Interactive comment on “Quantifying the impacts of human water use and climate variations on recent drying of Lake Urmia basin: the value of different sets of spaceborne and in-situ data for calibrating a hydrological model” by Seyed-Mohammad Hosseini-Moghari et al.

Received and published: 3 November 2018

Fig. 1. Annual inflow to the lake

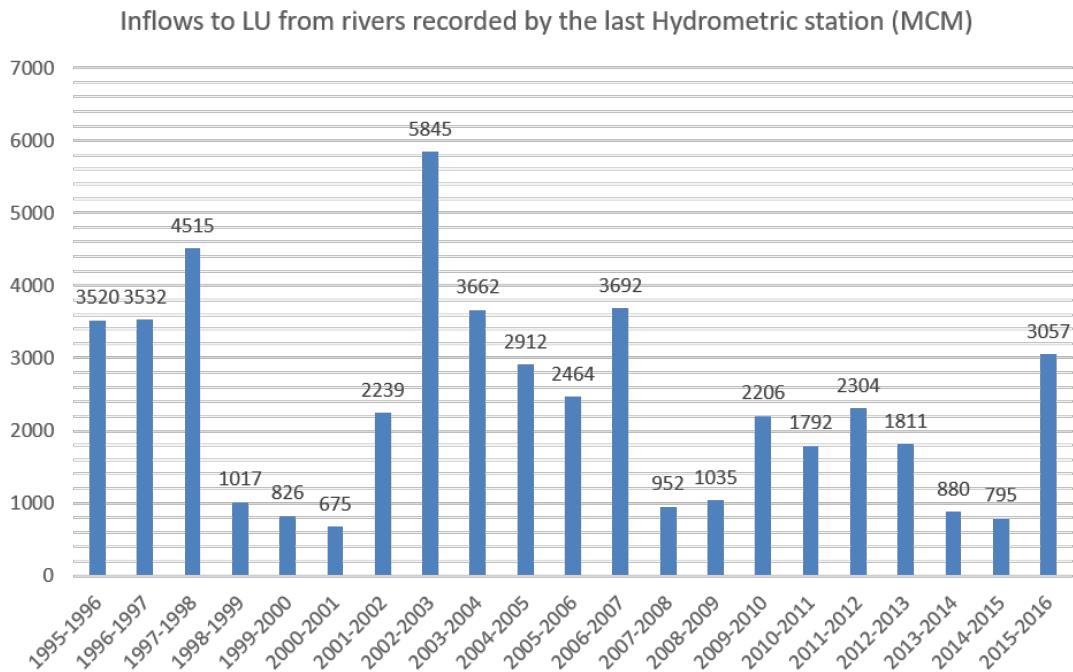
In their analysis, authors only considered the time period 2003-2013. It is not clear why both earlier years and the most recent years are excluded from the analysis. It is well-known that there has been significant changes in the basin and the lake water level since late 1990s. Using a statistical change point analysis, Khazaei et al. [in review] identified the year 2000 as the beginning of the period with significant changes in the lake dynamics. So, it is crucial to include all the years post 2000—the data availability is not an issue as ULRP now provides researchers with required data. For instance, annual inflows to the lake are highly variable during this period (see the supplement figure), which you also used for calibrating the model. Given such degree of variability, the modelling results are likely sensitive to this variable, and it is important to use the entire time period.
